**Gore RCN-8818 Cable  
for RBSP Spin Plane Boom  
RBSP-SPB-TN-025 Rev B**

Detailed Inspection  
Performed by Greg Dalton 1/8/09  
Space Sciences Lab – UC Berkeley  
UCB PO# 1-0001382652  
Gore PO A74-32016  
Sales Order #13807978  
Work Order #2294768

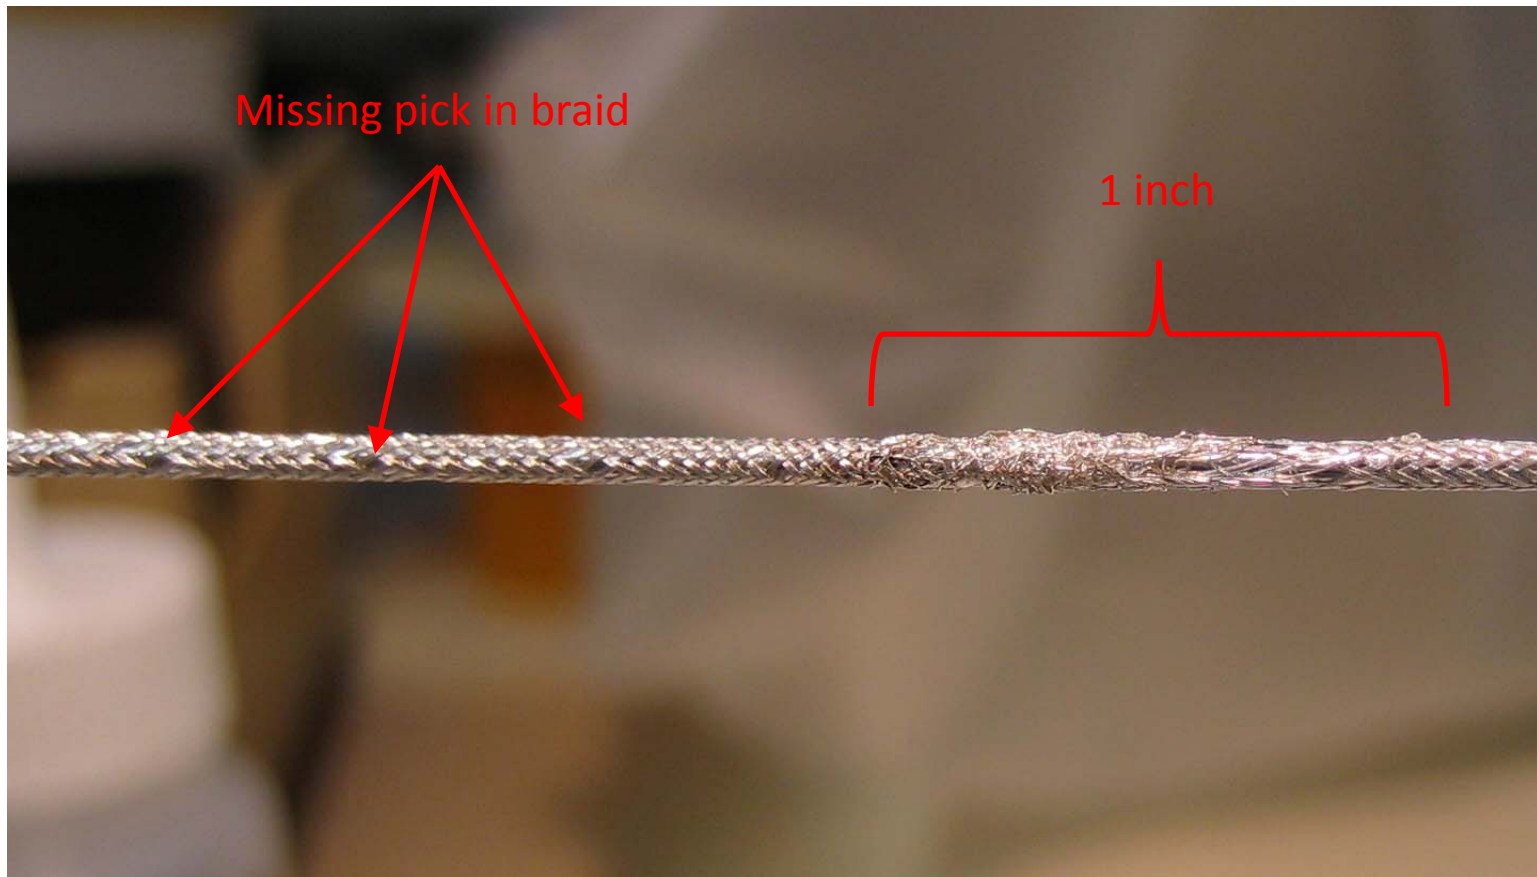
At the 174 ft mark, there is a severe defect approximately 1 in long in the outer SPC braid. Cable to the left of the braid shows an outer SPC pick missing or broken.

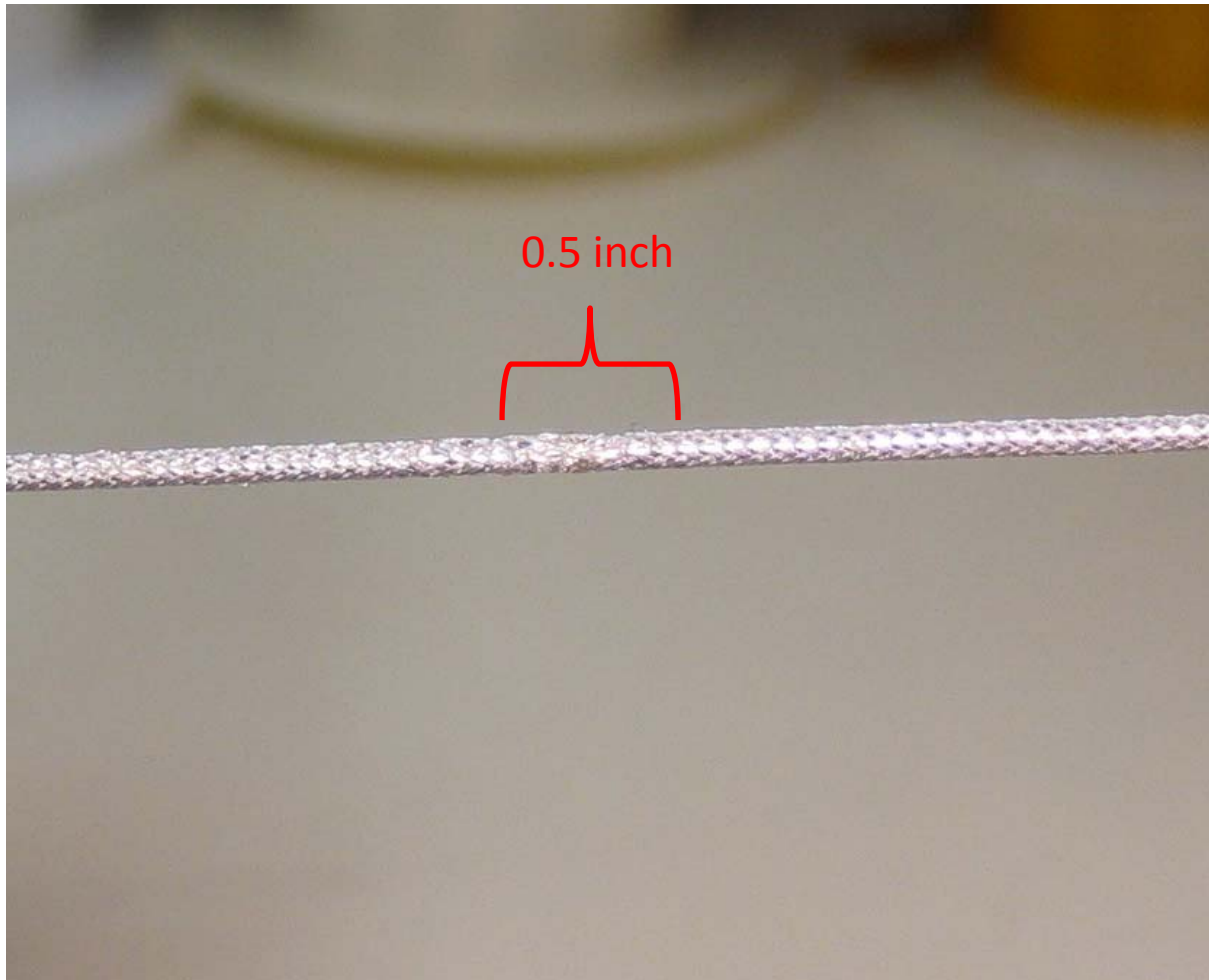
At the 533 ft mark, there is a defective section approximately 0.5” inch long in the outer SPC braid.

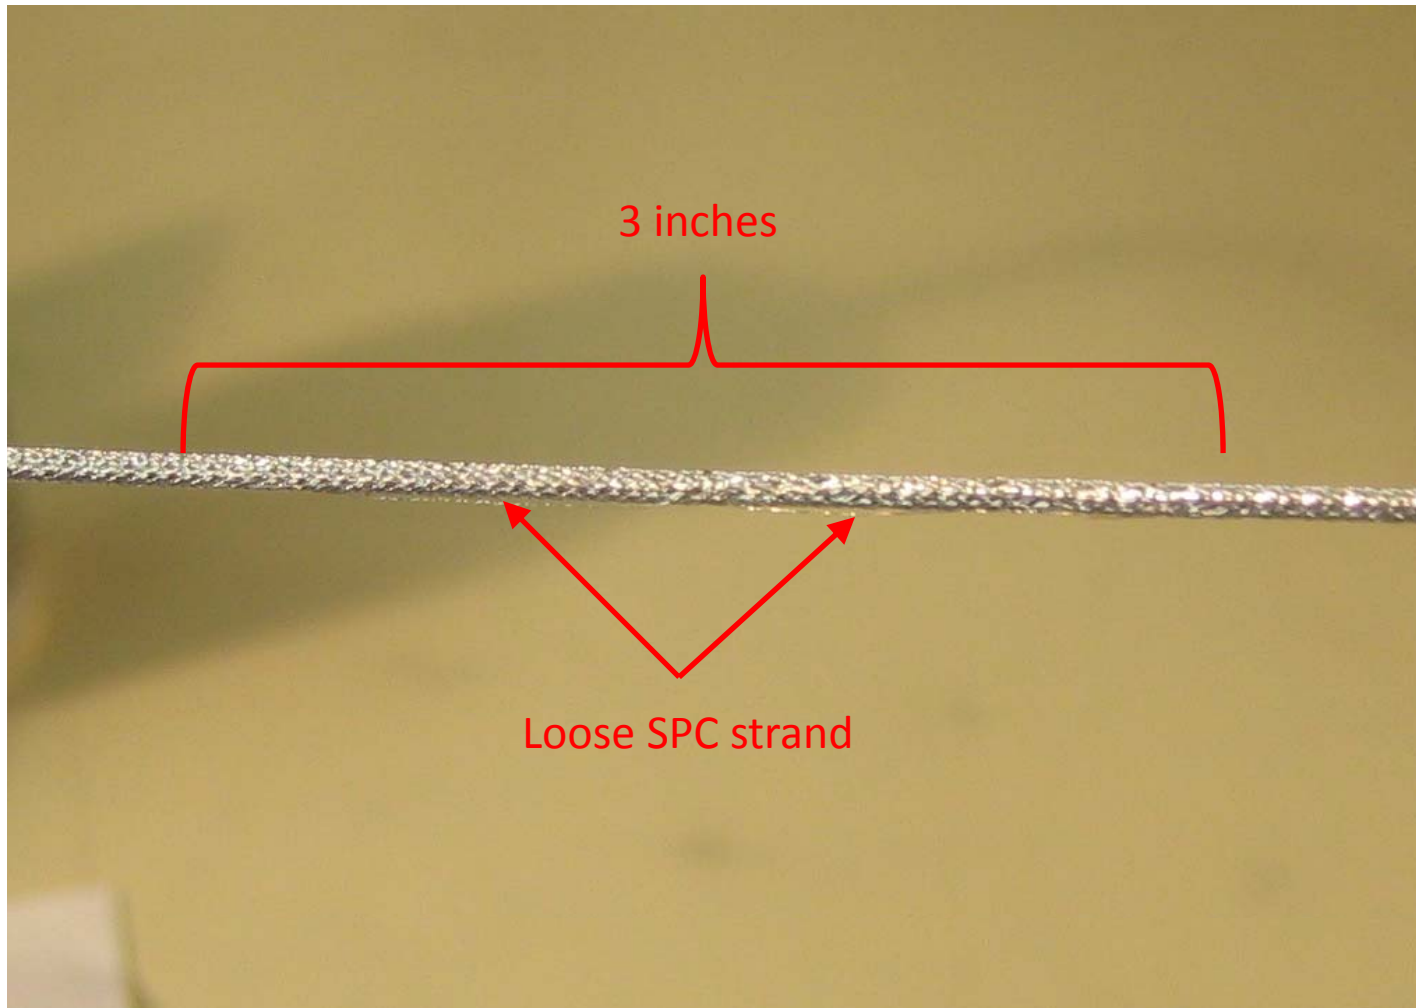
A few inches from the 533 ft mark, there is a second defect approximately 3 inches long that has a strand of SPC running outside the braid. Other minor defects in outer SPC braid were noted within 6 inches of this mark.

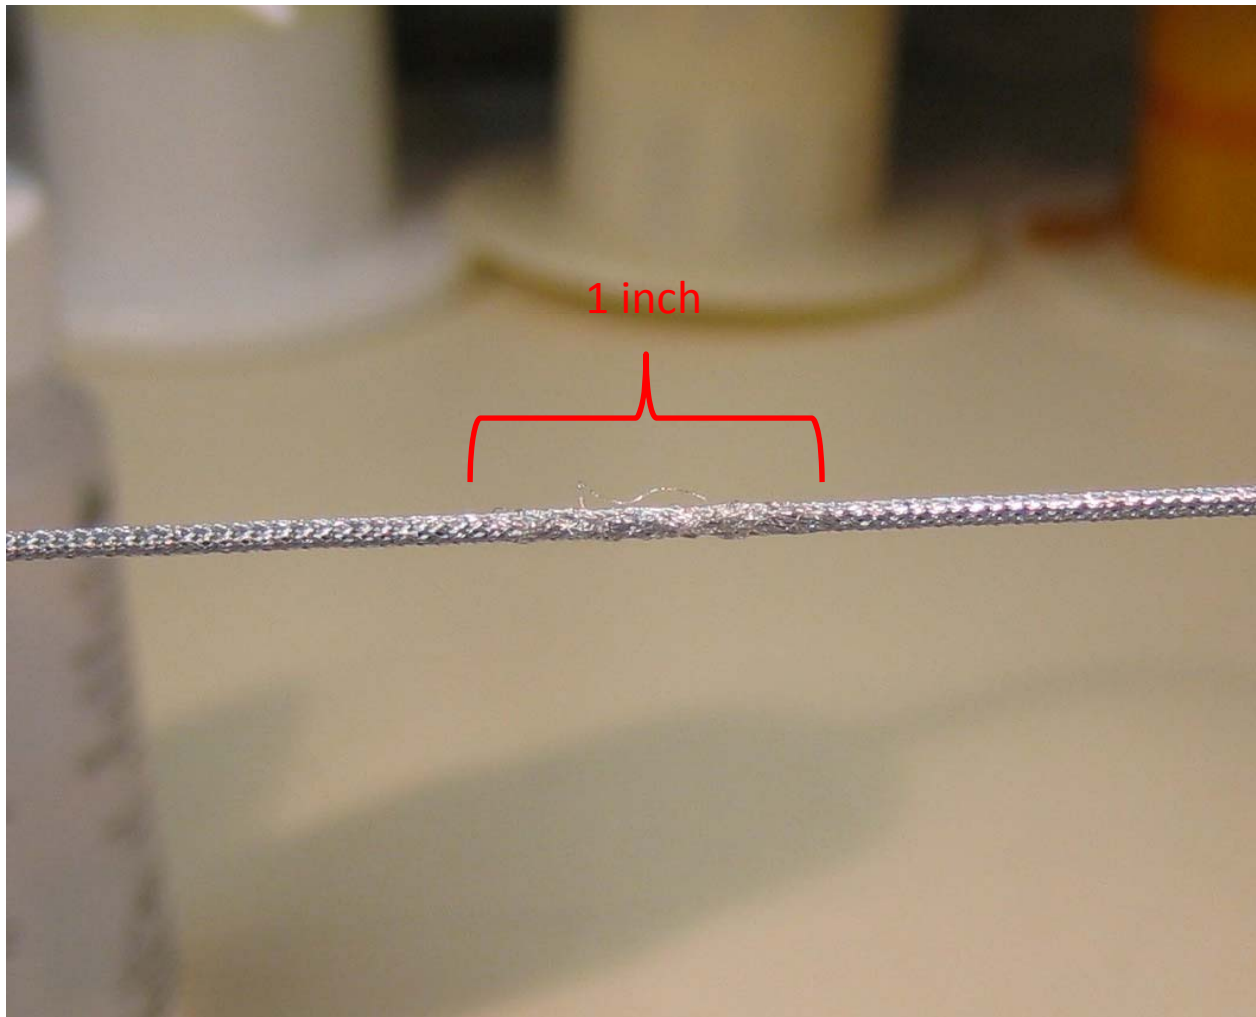
At the 589 ft mark, there is a severely defective SPC braid section approximately 1 in long. There are also a few other minor defects in the SPC braid within 10 inches of this mark.

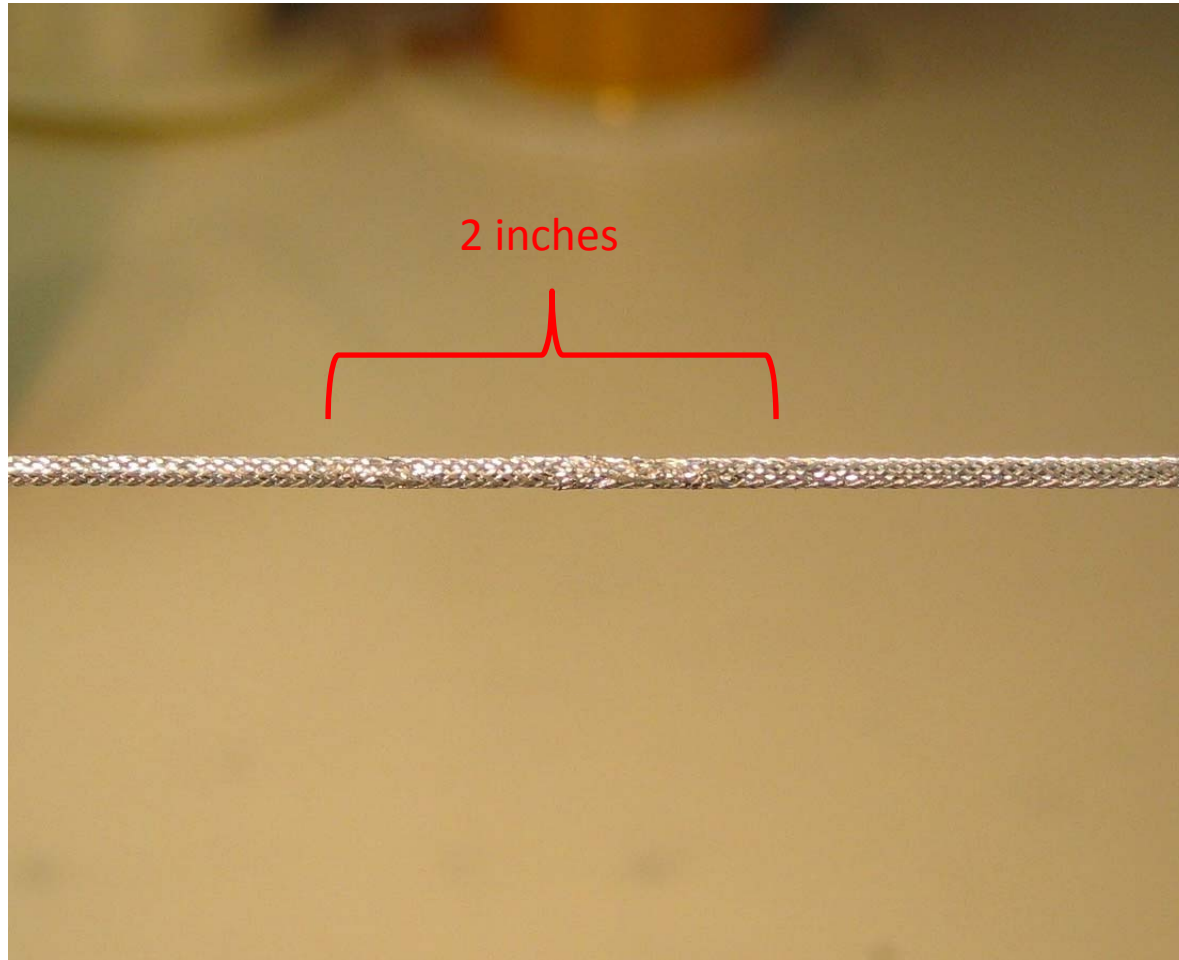
At the 907 ft mark, there is an approximately 1 in section of defective SPC braid.  
There are also a few other braid defects within 8 inches of this mark.

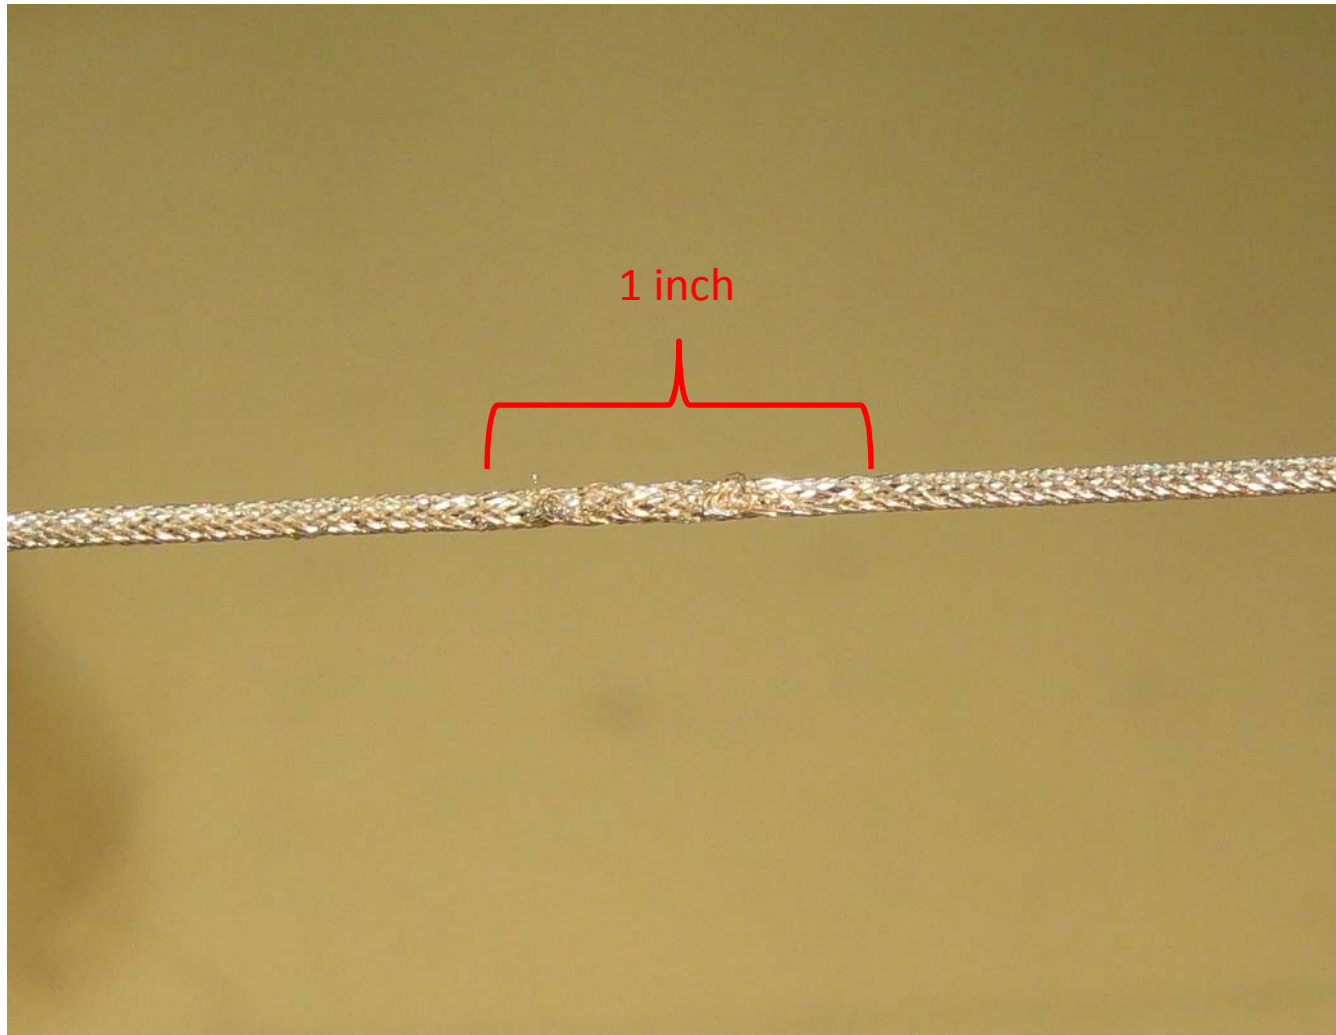
At the 1730 ft mark, a severely defective section. Other minor SPC defects within 6 in of this mark.

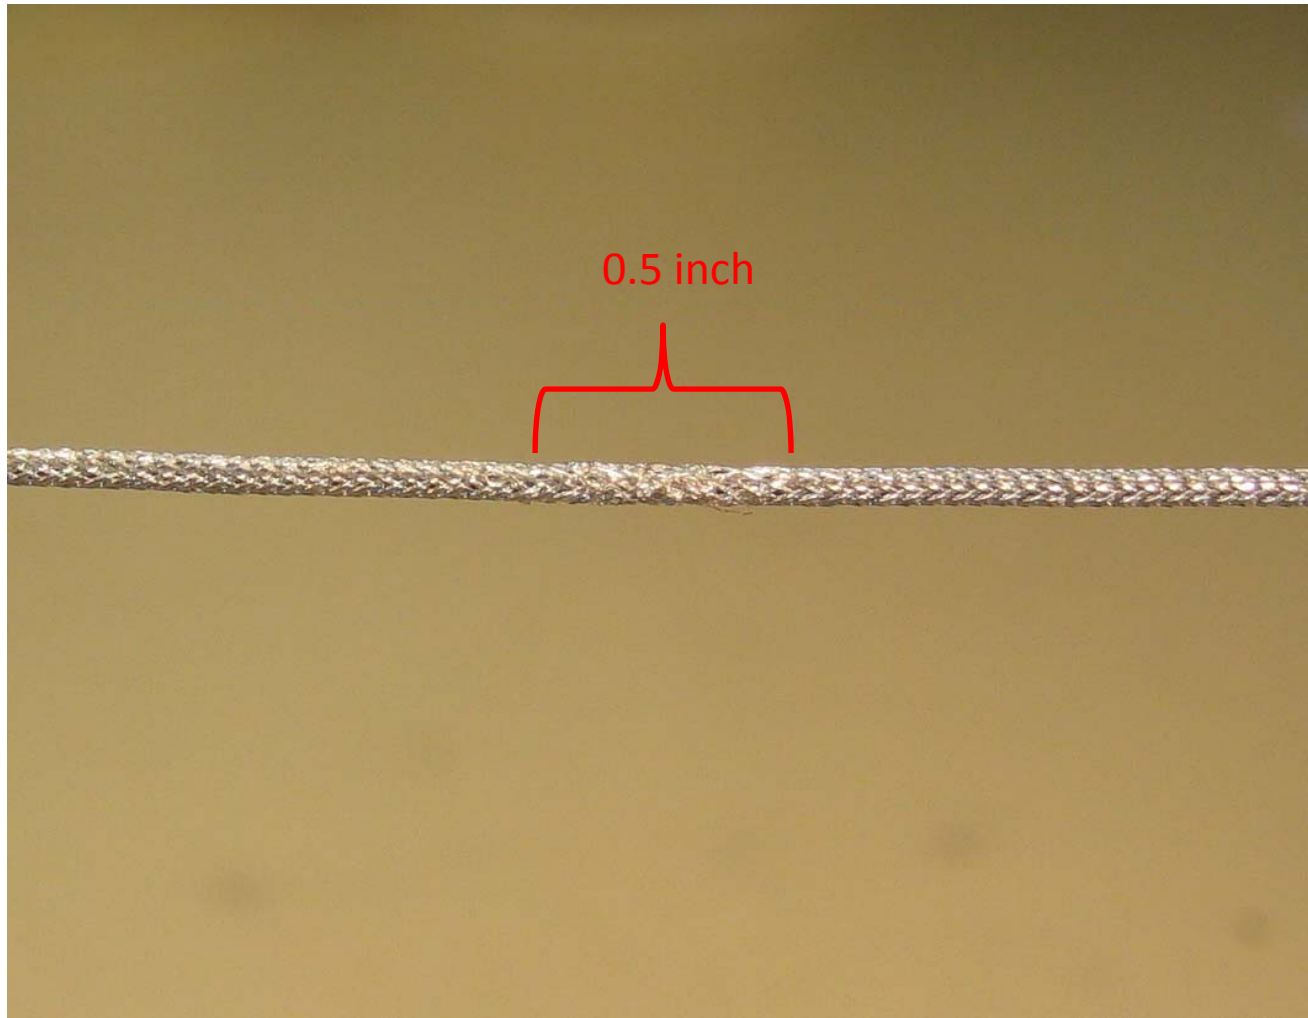
At the 2049 ft mark, there is a approximately 0.5 in SPC braid defect. Other minor defects are within 6 in of this mark.

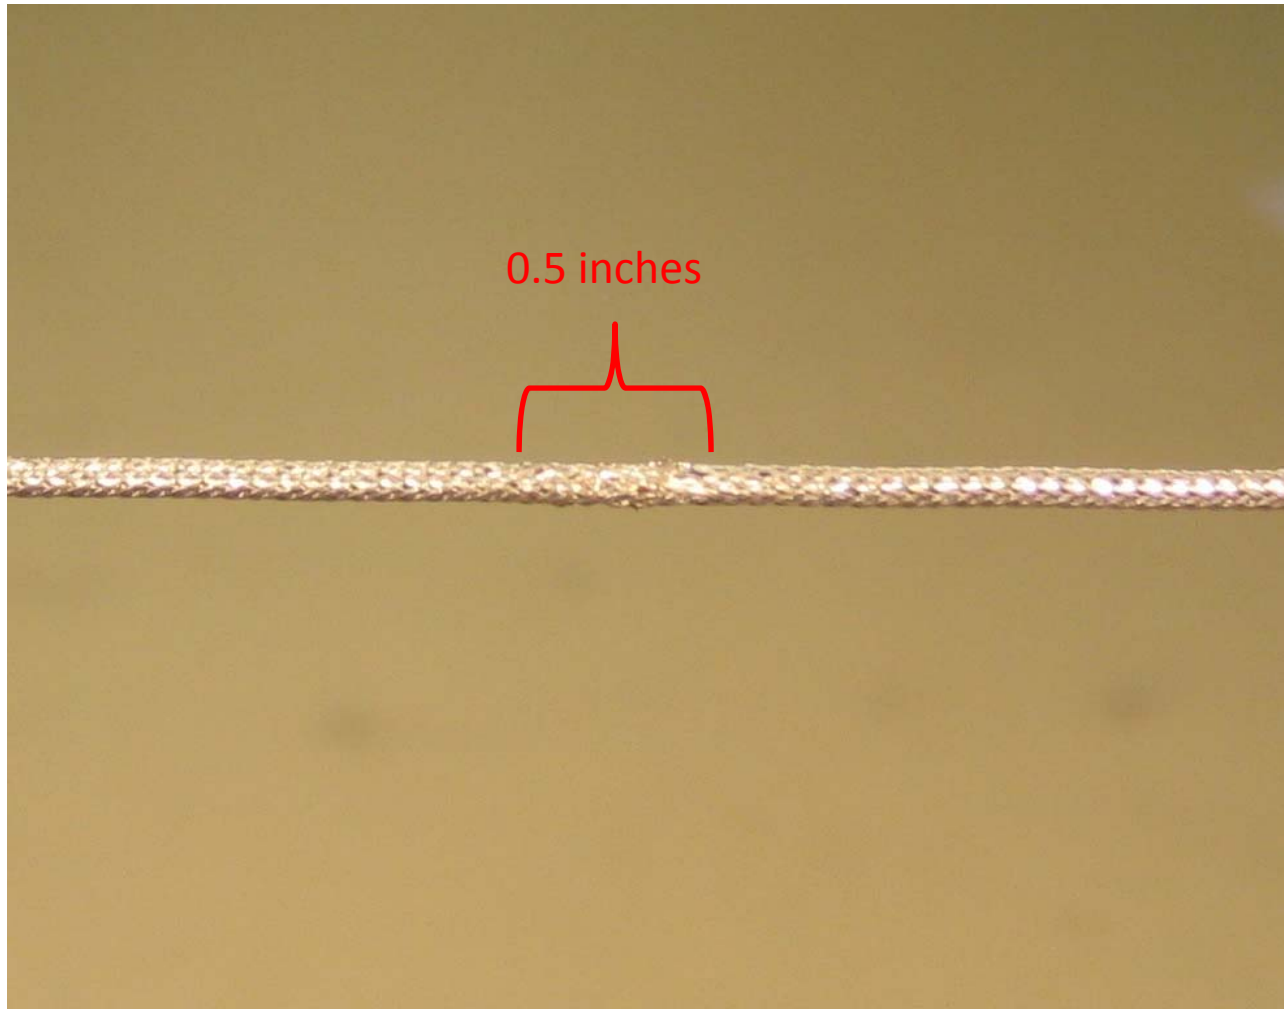
At the 2184 ft mark, a defect in the SPC braid. Other small defects are within 6 inches of this mark.
